HIGHWAY MAINTENANCE BULLETIN #6/2008

Wood Sign Posts within Highway Right-of-Way

DWG. No.	TEB 1.81
	Date	JUNE 13/08
	Revision	
	Revision	
<p>TYPICAL BREAKAWAY WOOD POST</p>

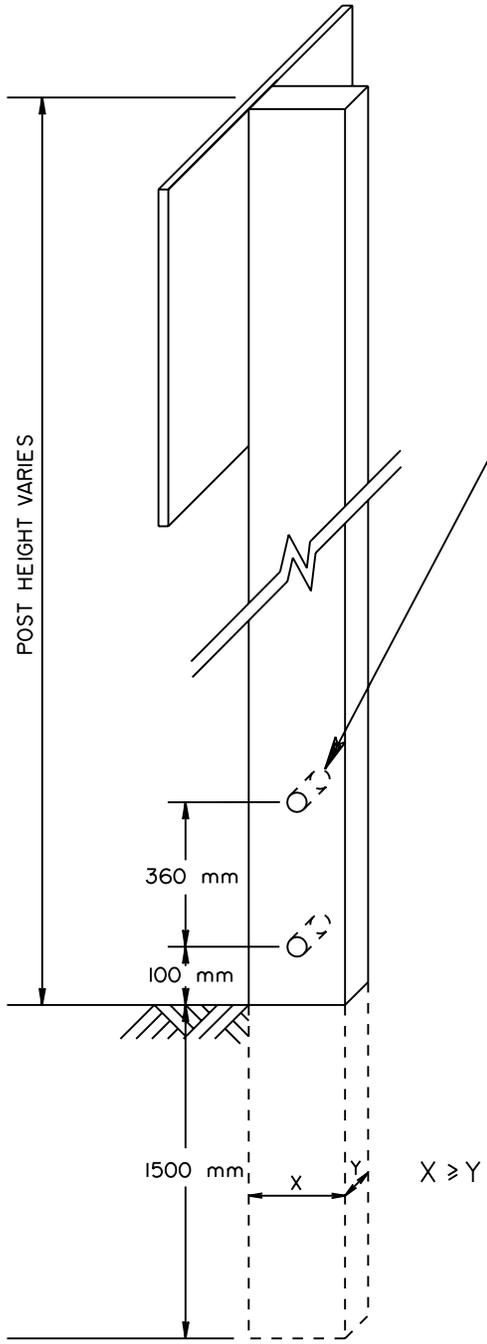
1. Existing wood sign posts with dimensions greater than 100 mm x 100 mm not required to be weakened.
2. All new and replacement wood sign posts with dimensions greater than 100 mm x 100 mm installed in the highway right-of-way must be weakened to meet breakaway requirements. The following post weakening features must be provided:

- Two 38 mm diameter drilled holes centered on the post, oriented in the direction perpendicular to the highway.
 - The first hole will be located 100 mm above the ground surface and the second hole will be located 460 mm above the ground surface (360 mm above first hole).

- Each hole should be filled with expanding Styrofoam flush with the face of the post.
 - Refer to [TEB 1.81](#) for more information.
3. Any existing wood sign posts with dimensions larger than 100 mm x 100 mm and that are part of a multi-post sign assembly are required to be weakened if they are deemed hazardous.

2-38 mm DIA. HOLES TREATED WITH AN APPROVED WOOD PRESERVATIVE.

FILL EACH HOLE WITH A SINGLE PIECE OF CLOSED CELL INSULATION FLUSH WITH FACE OF POST (E.G., EXPANDING STYROFOAM). THE HOLES DO NOT NEED TO BE FILLED IF PRE-TREATED AT THE PLANT OR MILL SITE.

HOLES ARE TO BE DRILLED PERPENDICULAR TO THE DIRECTION OF TRAFFIC FLOW.
